CERTIFICATE OF APPROPRIATENESS

Property: 518 W 13th Street, E 69.2 ft of Lots 34, 35, & 36, Block 182, of Houston Heights

Proposal: Alteration/Revision—

Revision to previously administratively approved COA, issued 2/22

Figure 1 - Approved Elevation 2/22

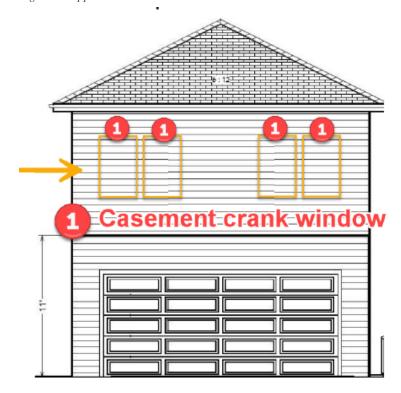
Recommendation: Denial - does not satisfy criteria AND issuance of a COR as applied for with condition that

the 4 windows be removed and reinstalled inset and recessed with historically accurate

trim.
